SITE NAME: ROUNDEL HOMES INC
BUILDER: GREENPARK HOMES

TYPE: TERRACOTA 1

REVIEWED

Building Permit #: **BP#-22-00086**

BASEMENT HEATING LAYOUT

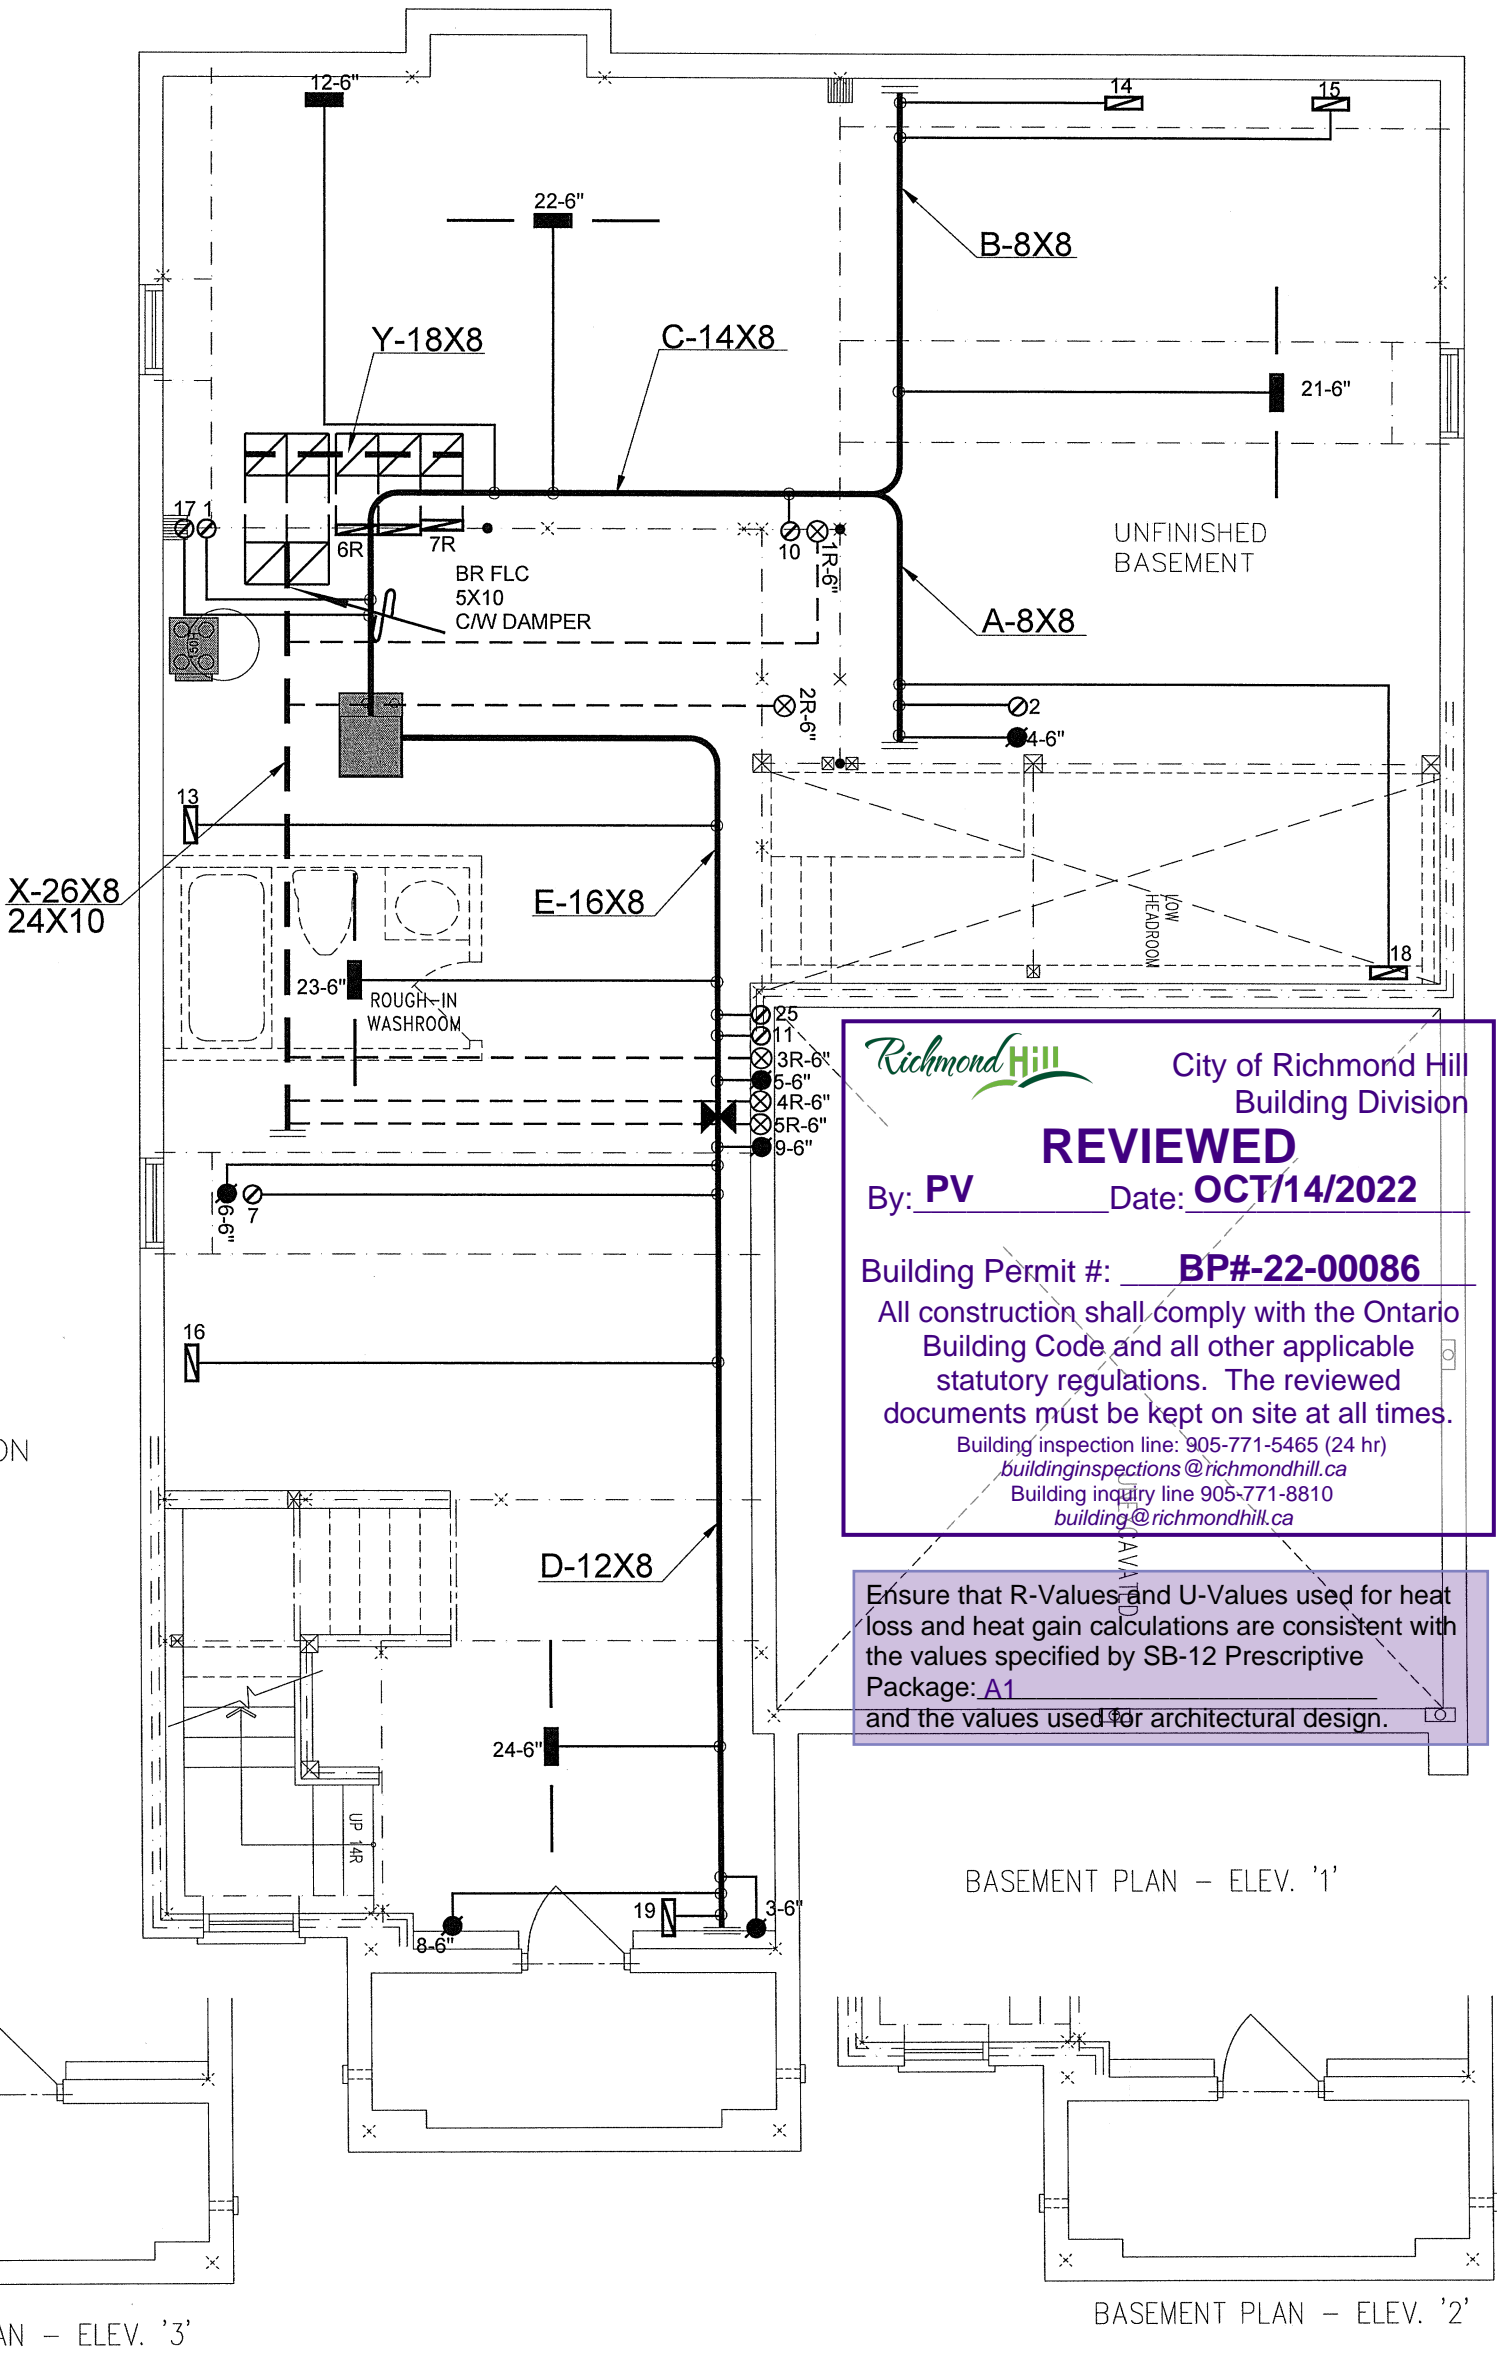
- 1.Laundry dryer exhaust duct shall be provided as per OBC 2012 Div.B 6.2.3.8(7).
- 2.Kitchen hood exhaust duct shall be provided as per OBC 2012, Div.B 9.32.3.10, 9.32.3.5(2).
- 3.Minimum R-12 Insulation Value required for ducts installed at unheated or exposed condition (OBC 2012 Div.B 6.2.4.3(10) and seal the ducts as per 6.2.4.3(11) & HRAI Digest 2005, Clause 4.5.
- 4.Penetration of Air Barrier System by ducts, wires, conduits or building materials shall be sealed as per OBC 2012, Div.B 9.25.3.3.(9) & (10).
- 5.Volume control dampers to all branches to be installed per OBC 2012, Div.B, 6.2.4.5.
- 6.Space between studs and joists used as return ducts shall be separated from unused portion as per OBC 2012 Div.B 6.2.4.7(6)

Ensure that R-Values and U-Values used for heat loss and heat gain calculations are consistent with the values specified by SB-12 Prescriptive Package: **A1** and the values used for architectural design.

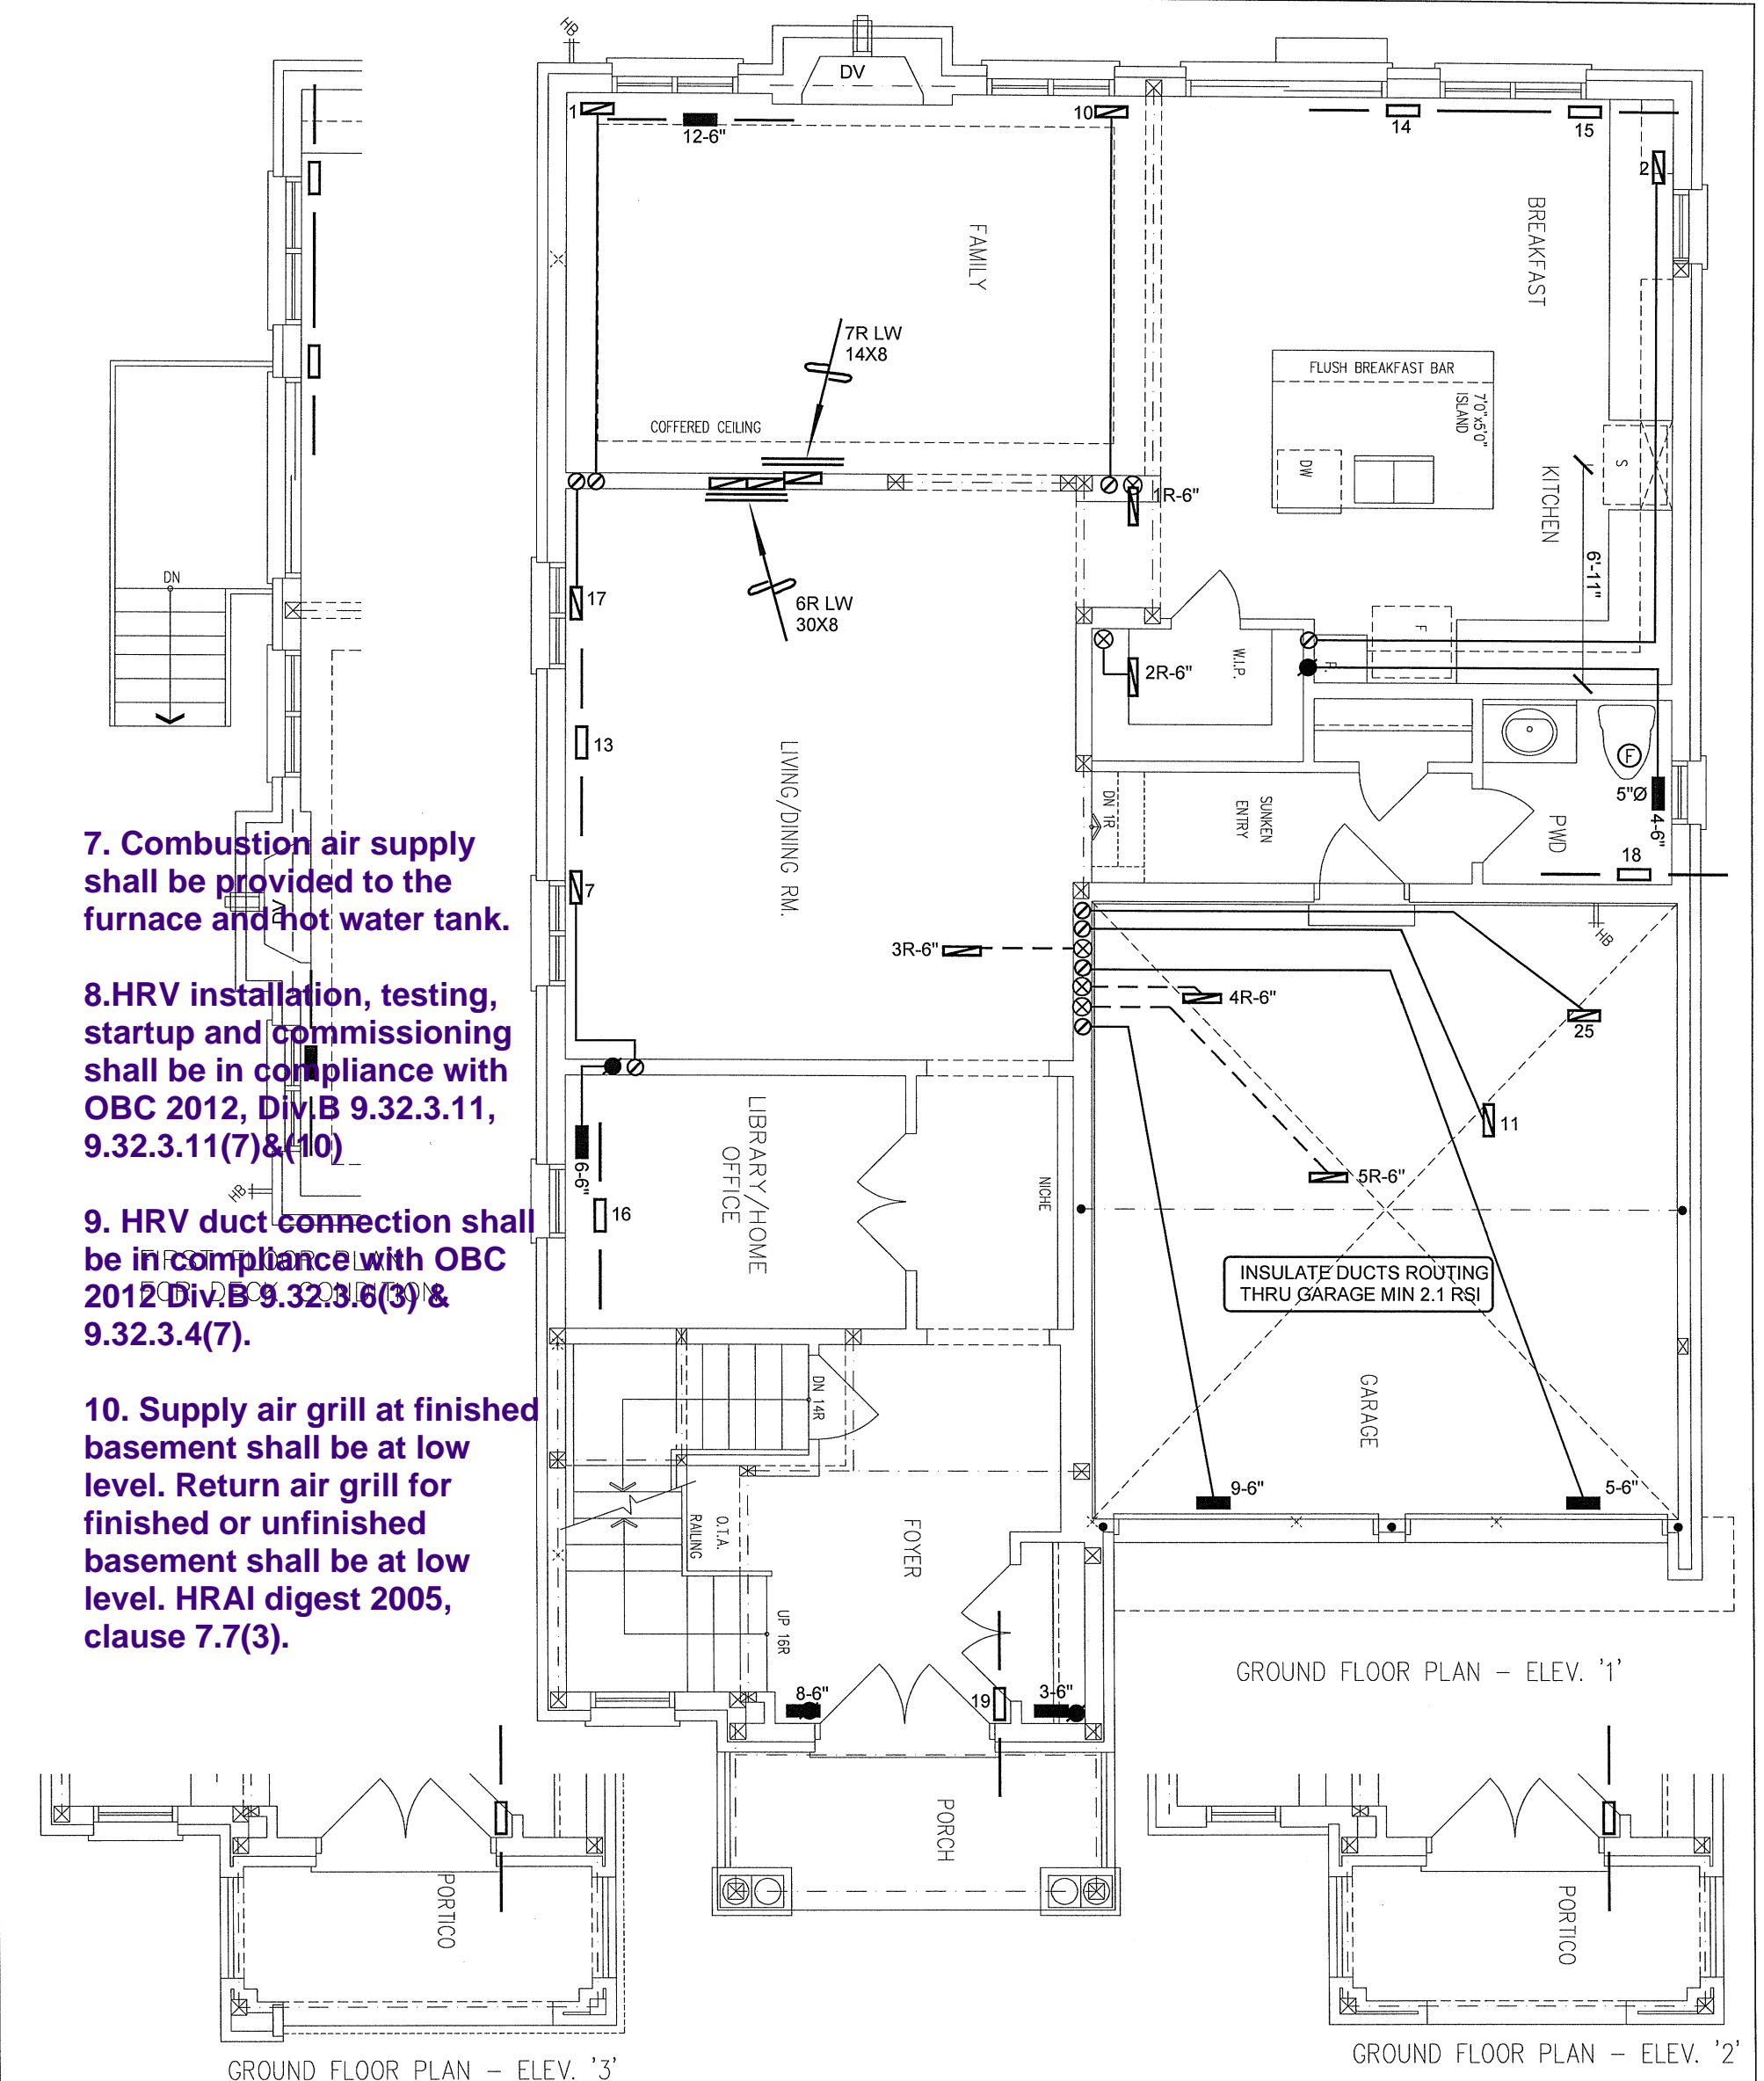
7. Combustion air supply shall be provided to the furnace and hot water tank.

8.HRV installation, testing, startup and commissioning shall be in compliance with OBC 2012, Div.B 9.32.3.11, 9.32.3.11(7)&(10)

9. HRV duct connection shall be in compliance with OBC 2012 Div.B 9.32.3.6(3) & 9.32.3.4(7).

10. Supply air grill at finished basement shall be at low level. Return air grill for finished or unfinished basement shall be at low level. HRAI digest 2005, clause 7.7(3).

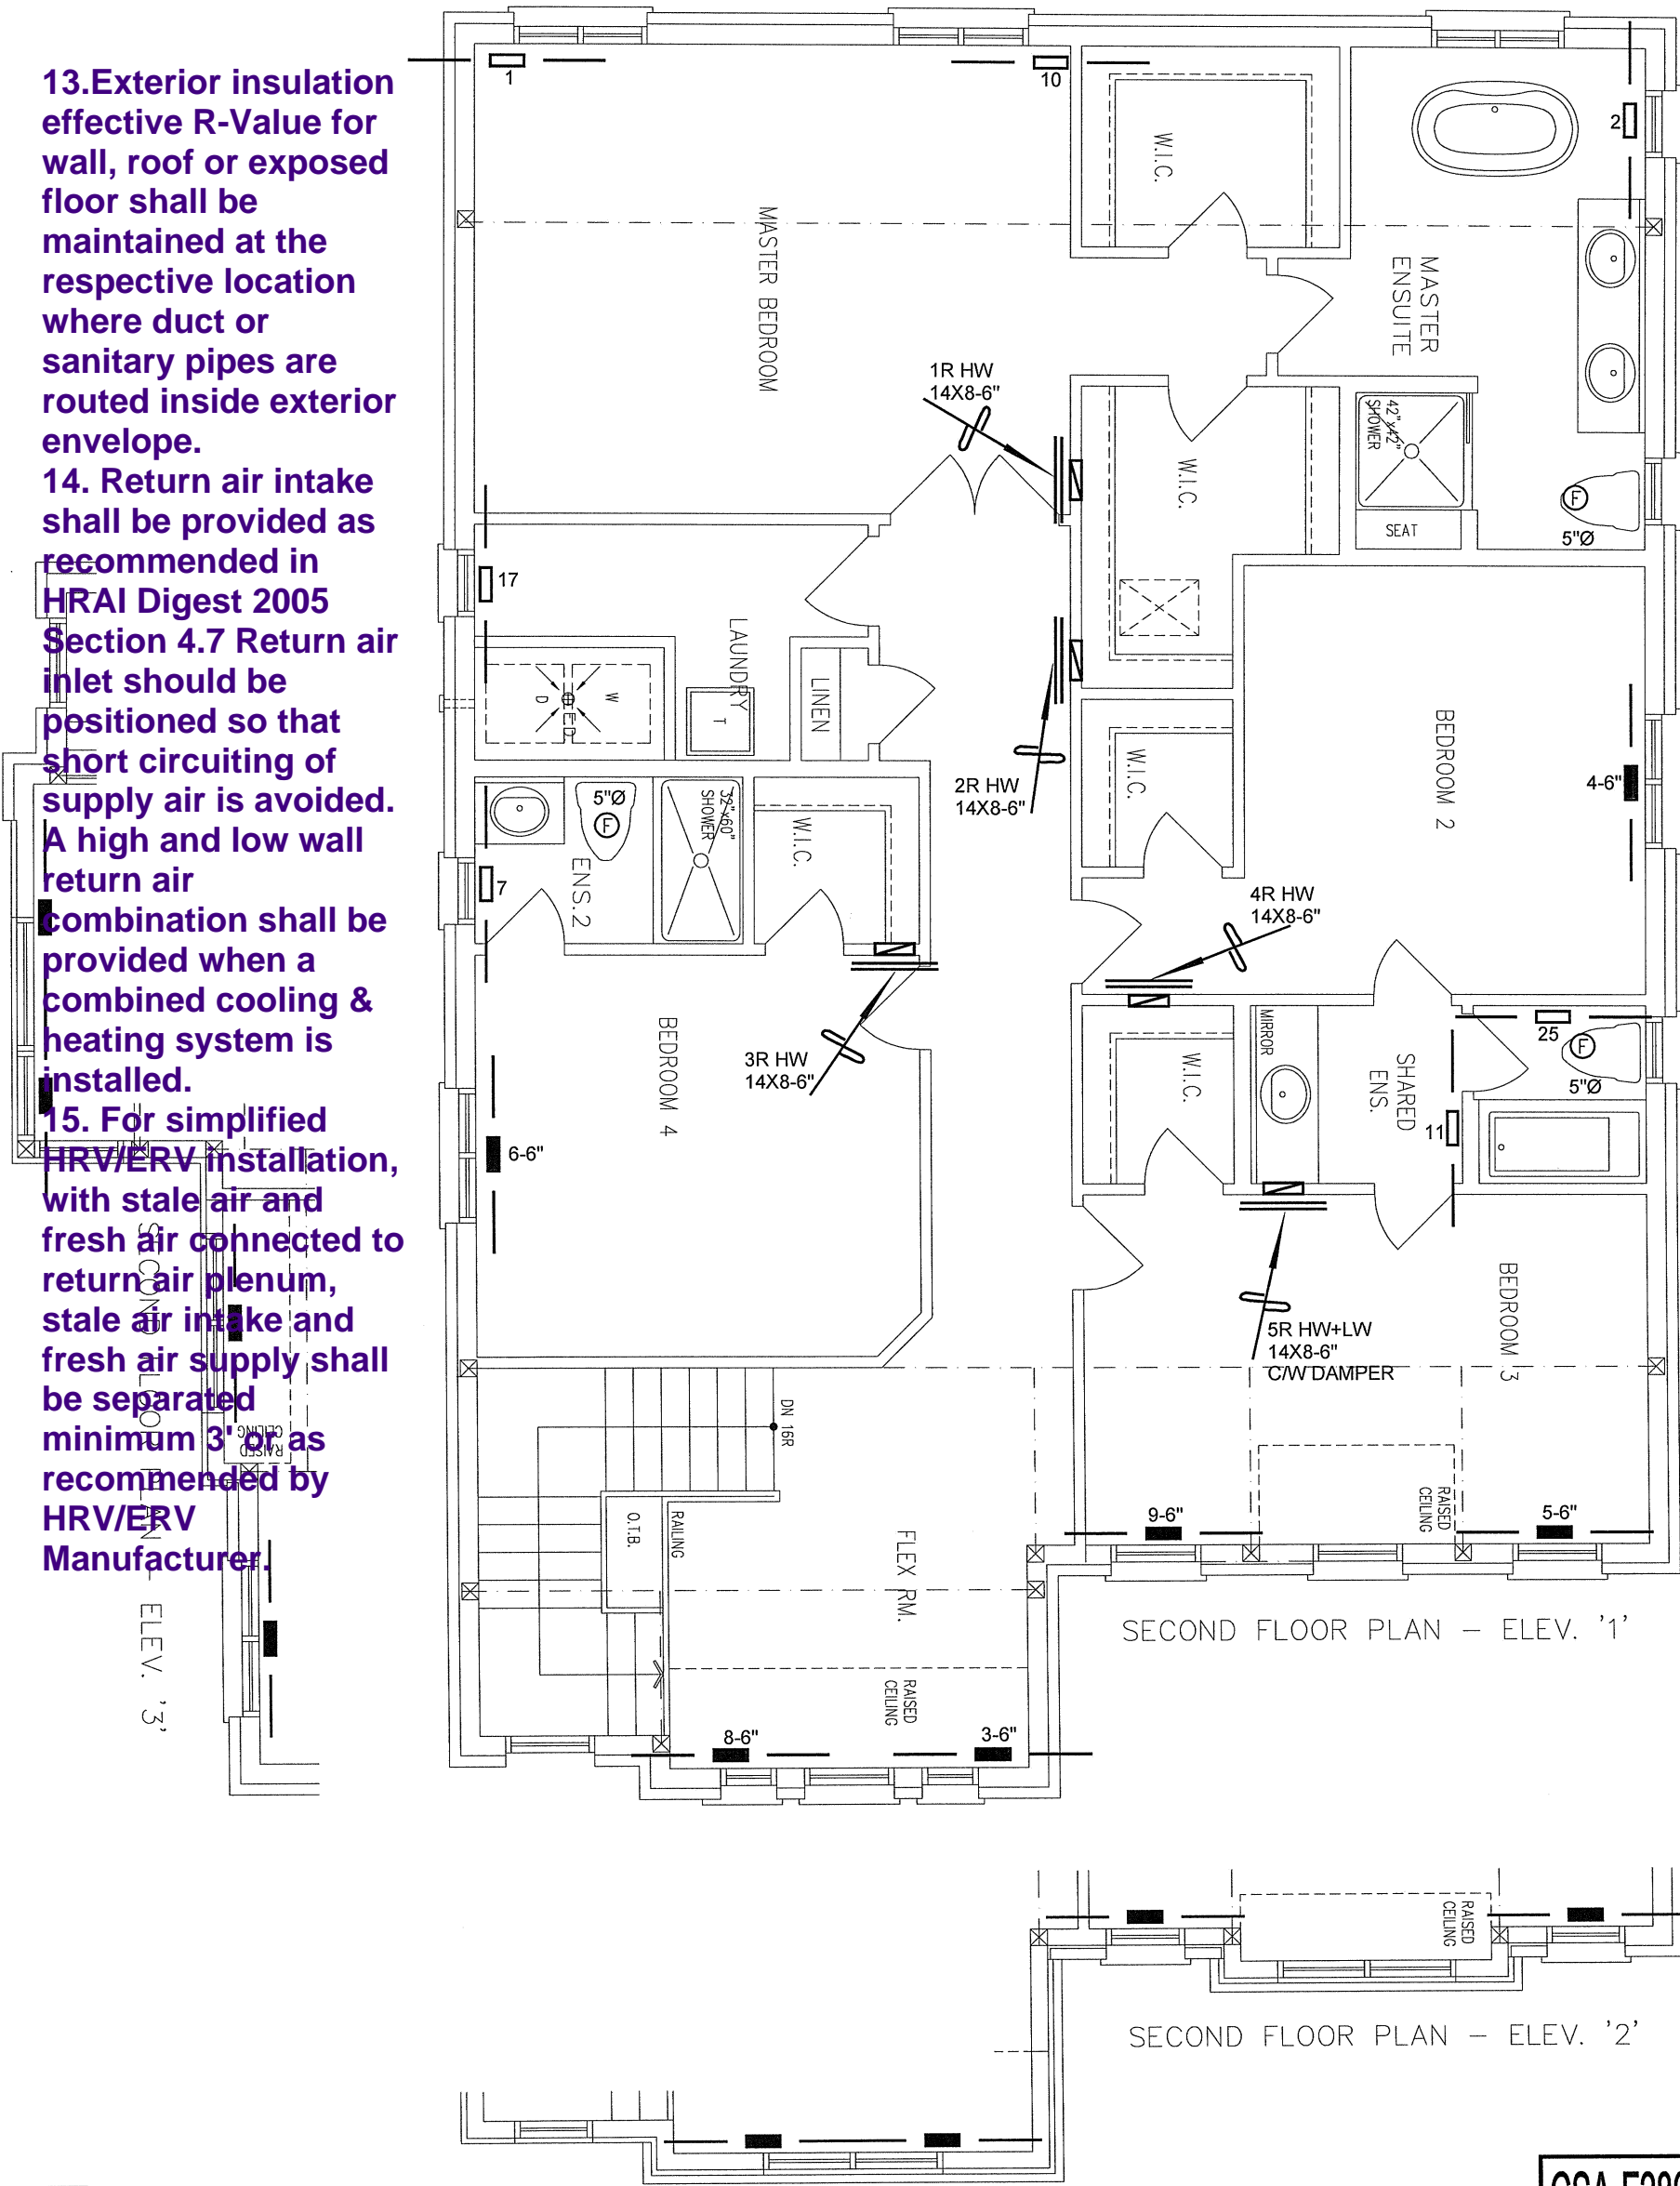
13.Exterior insulation effective R-Value for wall, roof or exposed floor shall be maintained at the respective location where duct or sanitary pipes are routed inside exterior envelope.

14. Return air intake shall be provided as recommended in HRAI Digest 2005 Section 4.7 Return air inlet should be positioned so that short circuiting of supply air is avoided. A high and low wall return air combination shall be provided when a combined cooling & heating system is installed.

15. For simplified HRV/ERV installation, with stale air and fresh air connected to return air plenum, stale air intake and fresh air supply shall be separated minimum 3' or as recommended by HRV/ERV Manufacturer.
